ADDENDUM NO. 01 (Date: June 27, 2022)

Fairhope Sewer Upgrade Phase I

Bid No. 005-22 – Lift Station Rehabilitation

Project: Lift Station Rehabilitation, ADCNR Grant #S1P25-FSU1

**NORTH SECTION
PROPOSED PLAN;
FORCE MAIN & GRAVITY
PROFILE**

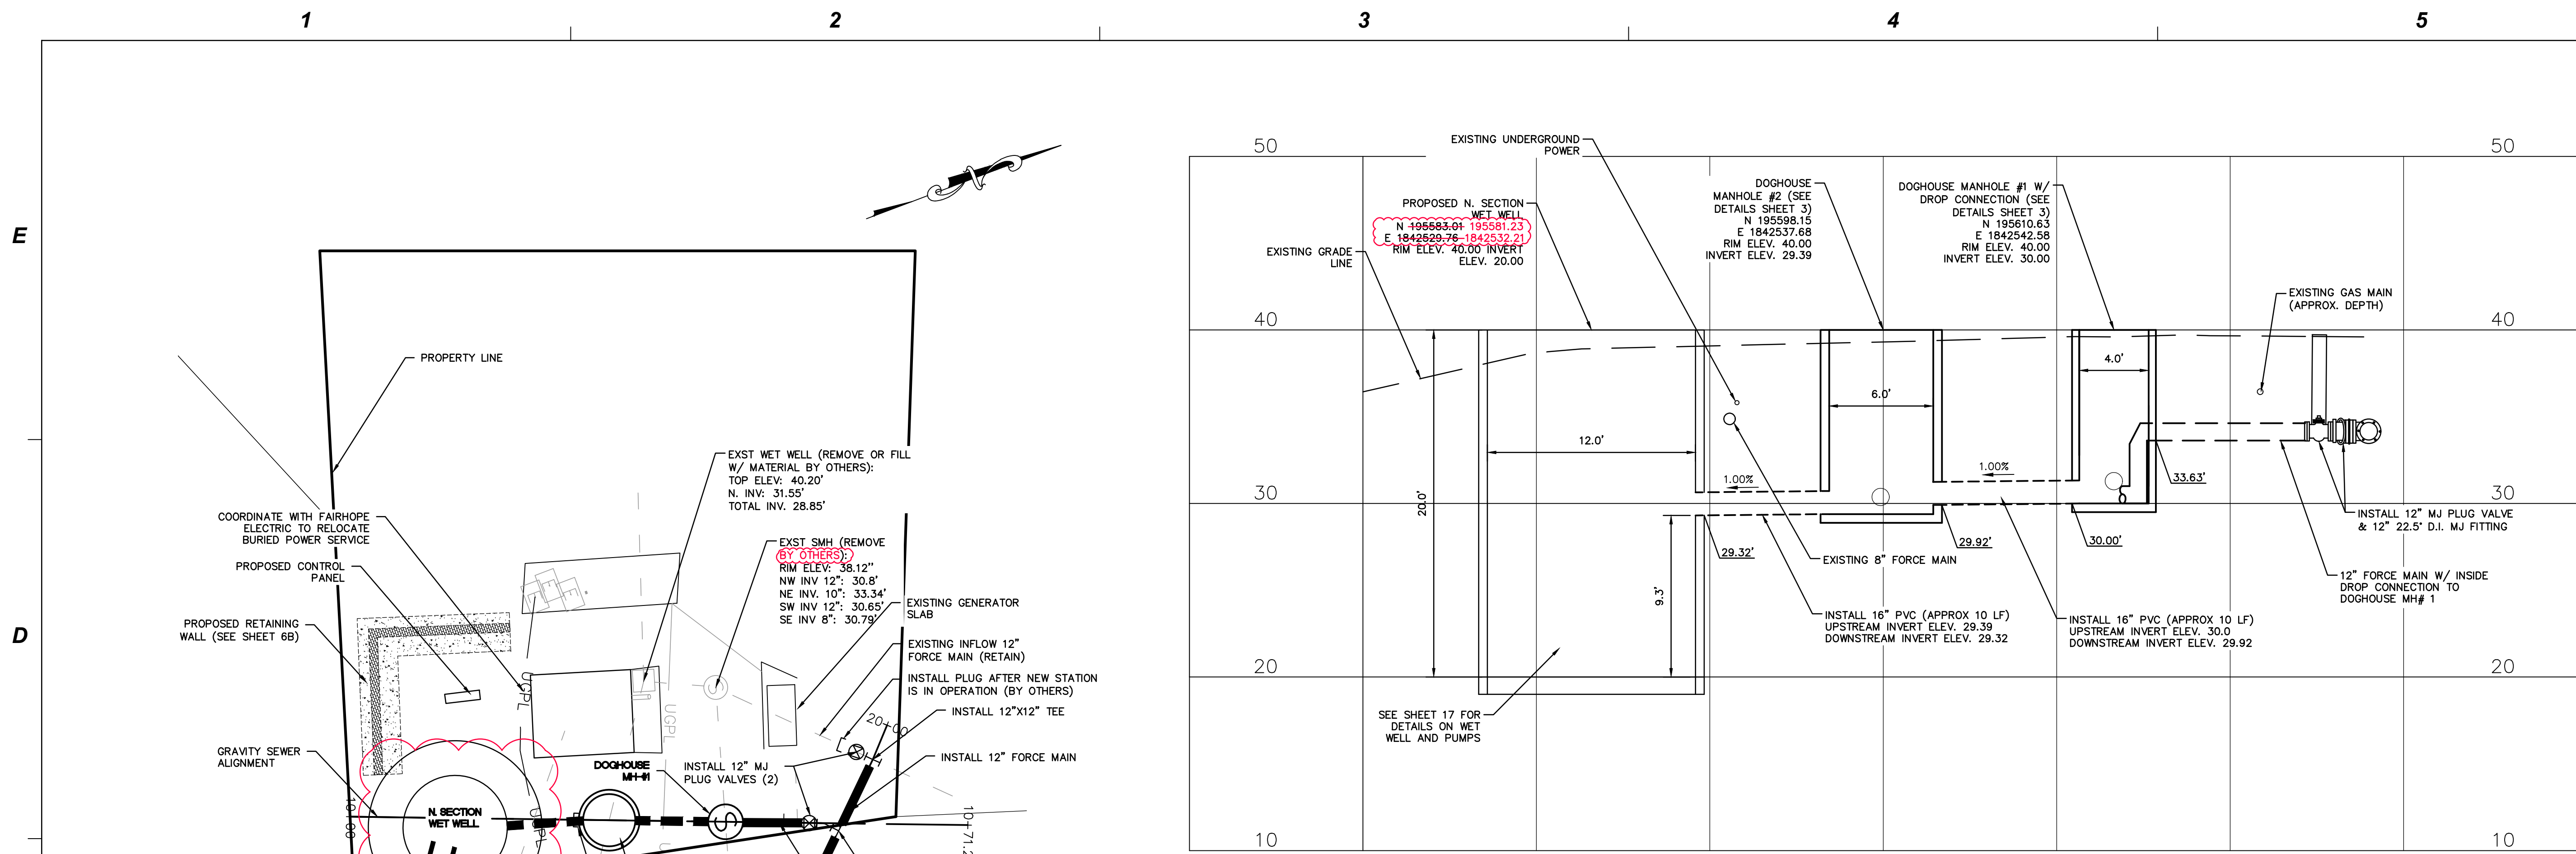
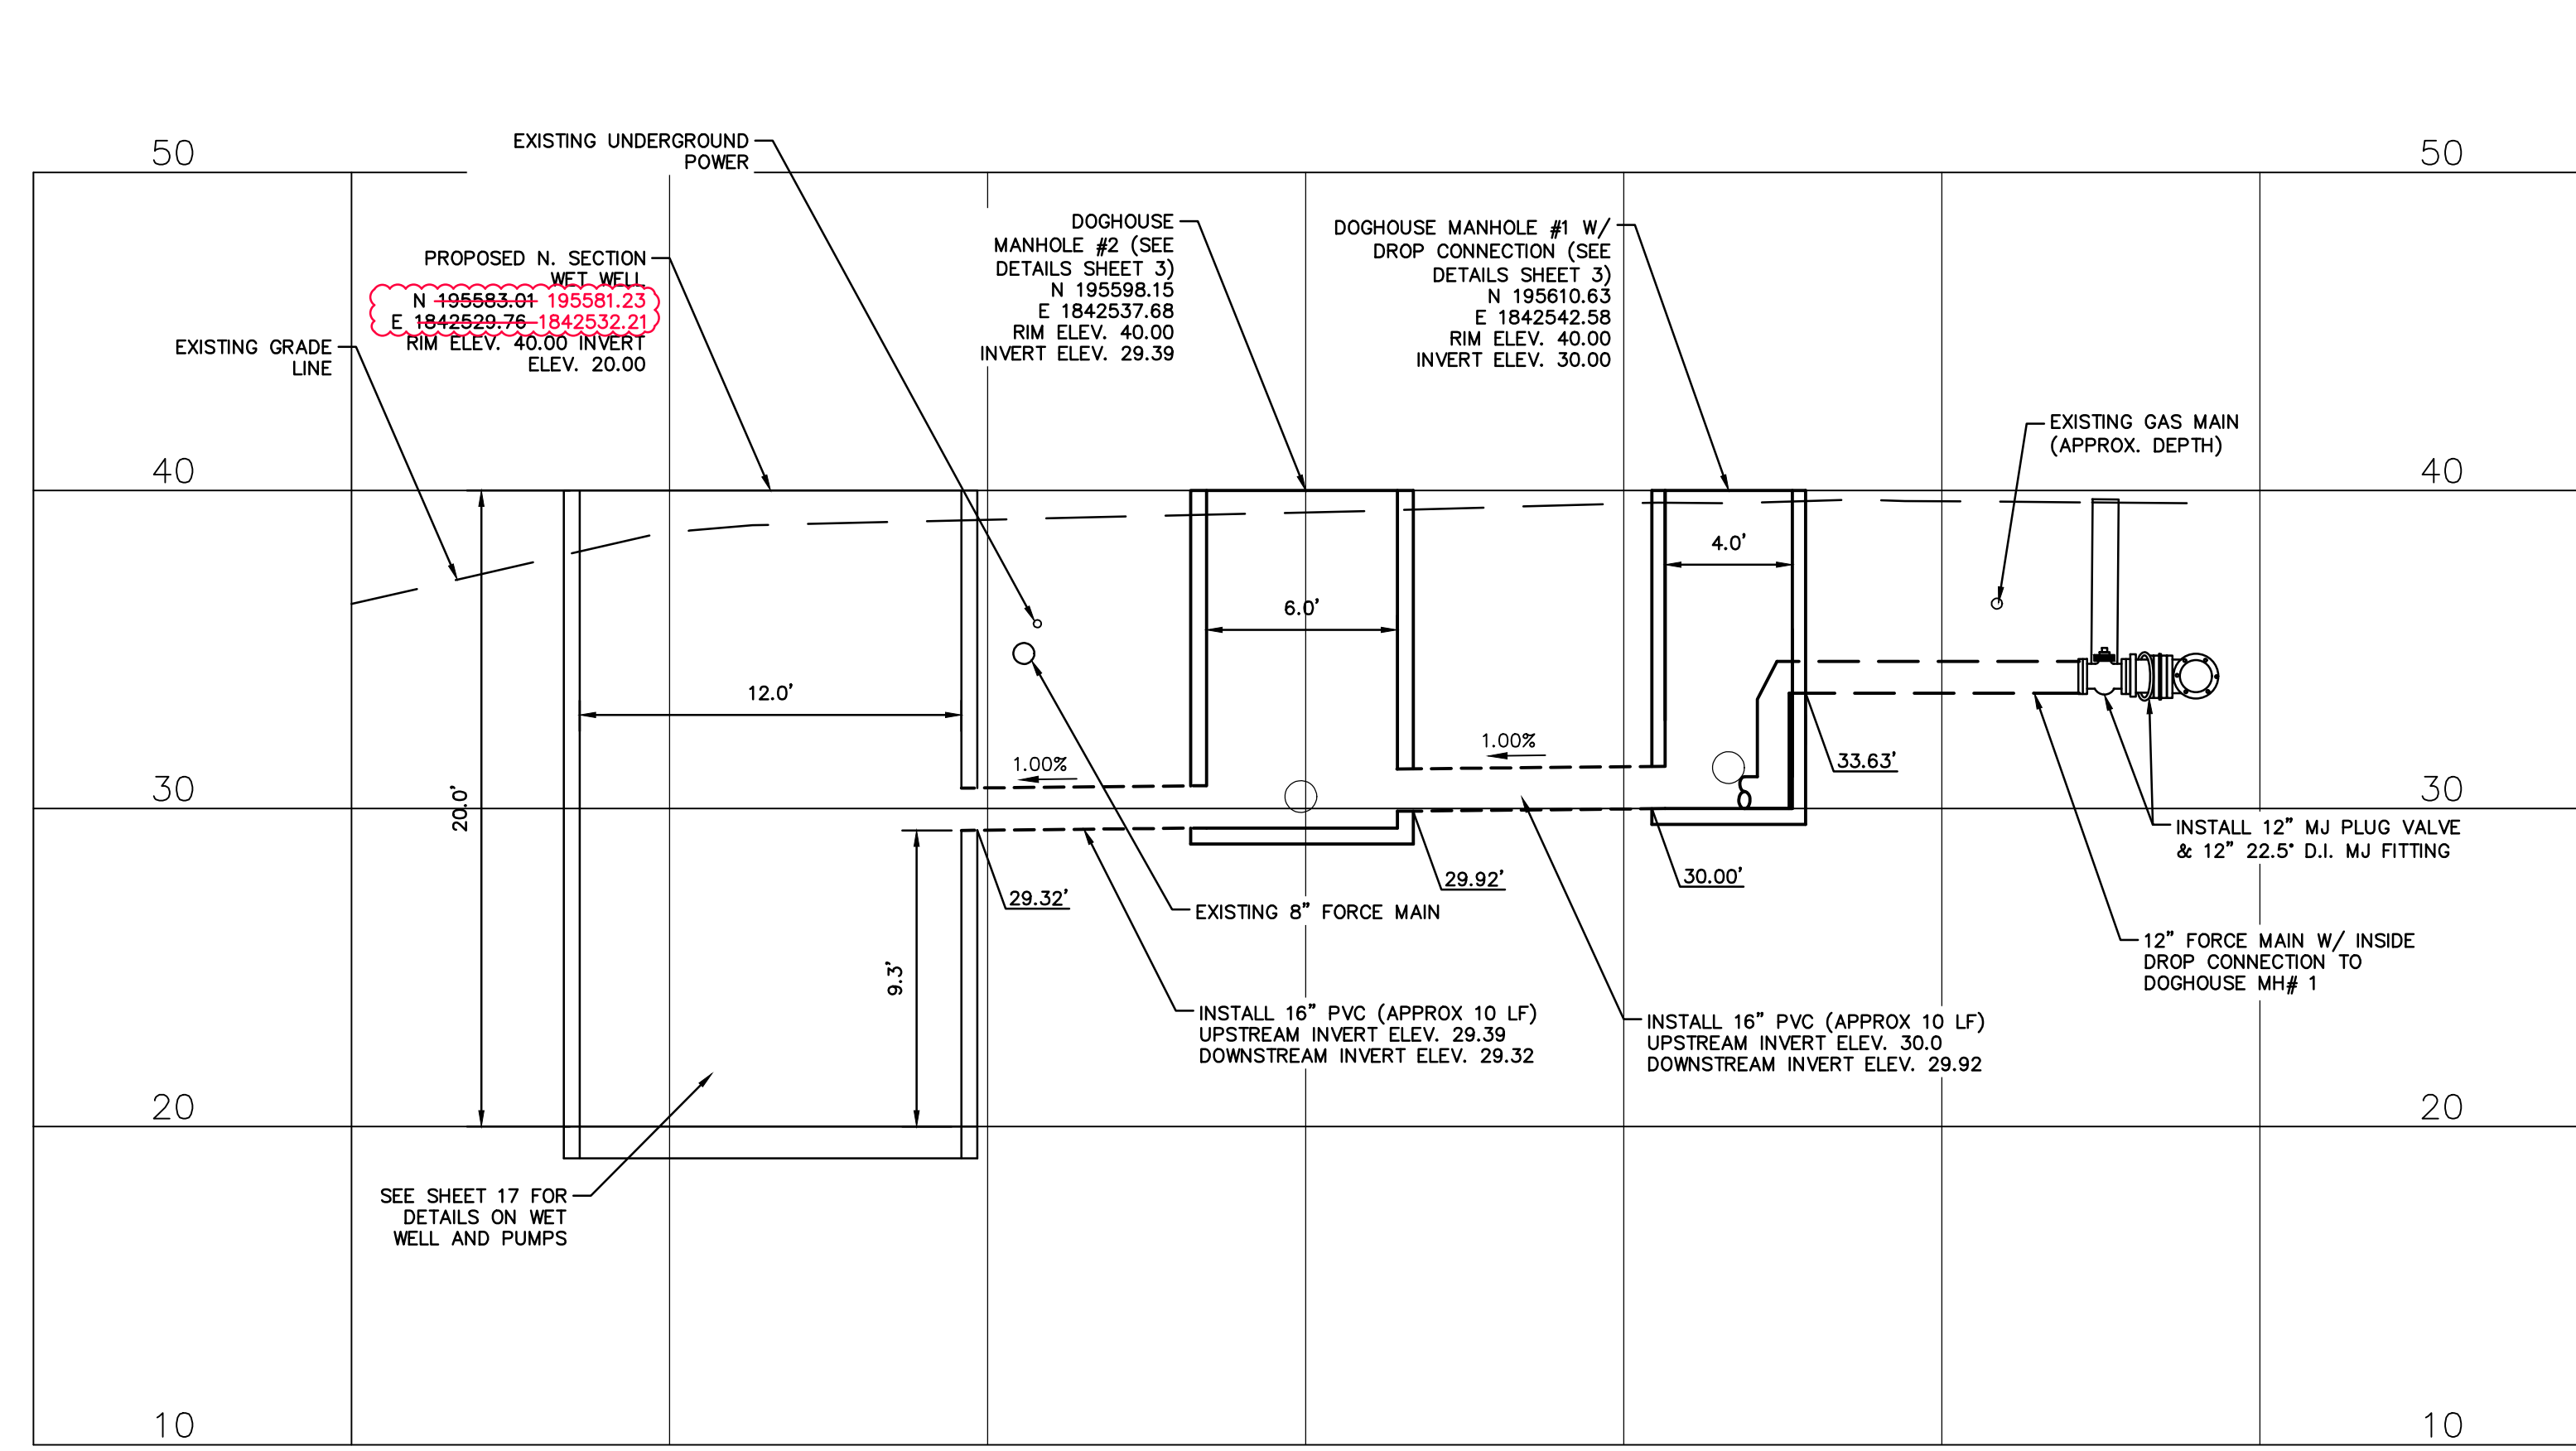
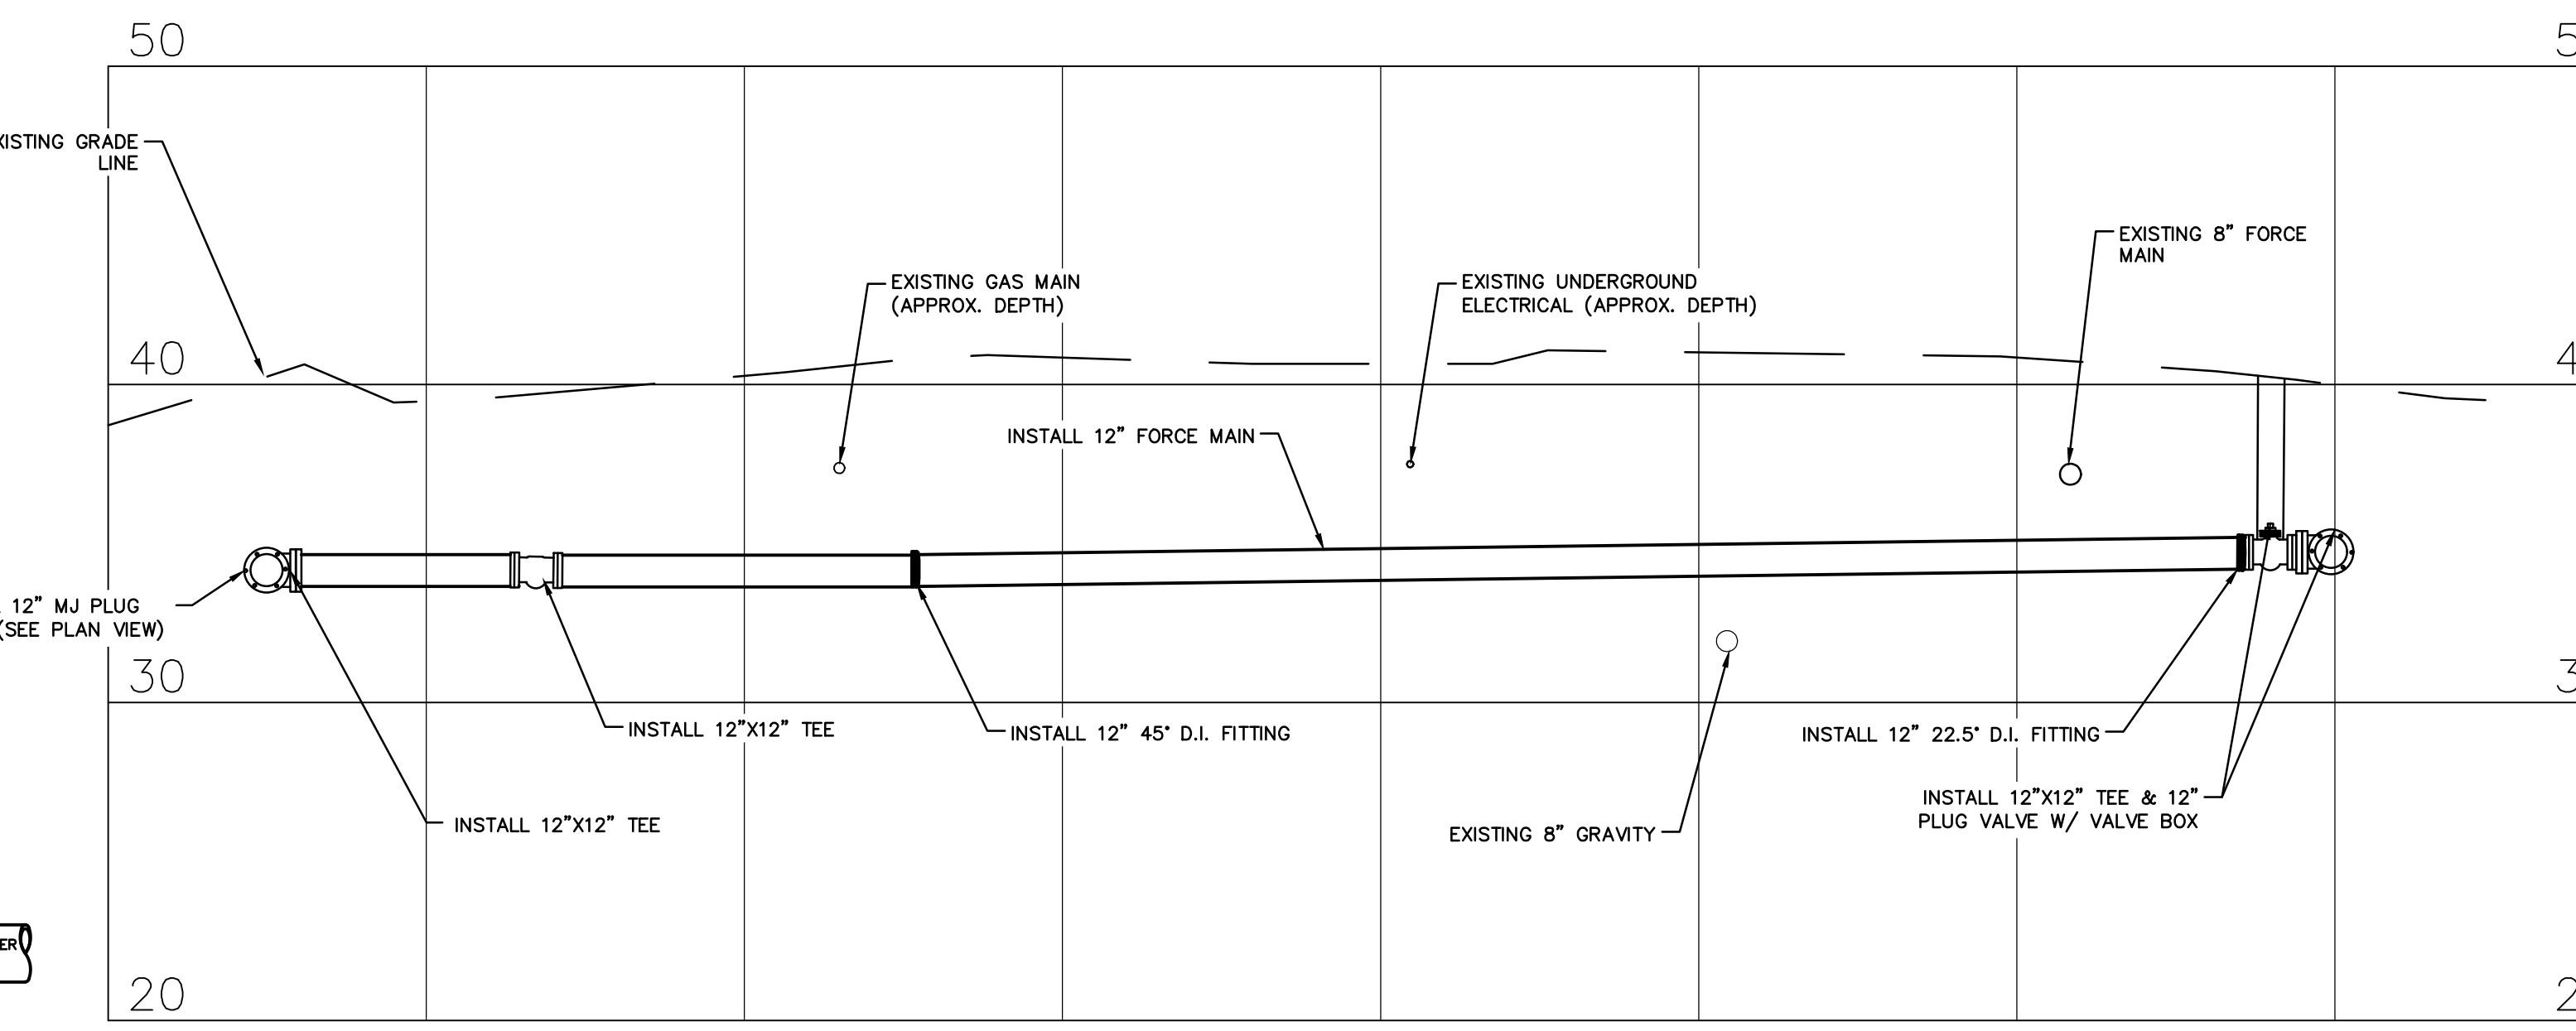
32. Question - North Section Lift Station, Dwg. 6, please confirm if the existing SMH indicated to be removed under this contract is correct. It does not seem possible if the existing wet well is to remain in operation and be removed later by others?

Answer: This manhole will be removed by others and is not apart of the current contract. See revision to plan sheet 6. The attached plan sheet will completely replace the previous version (IFB 5/23/22) in its entirety.
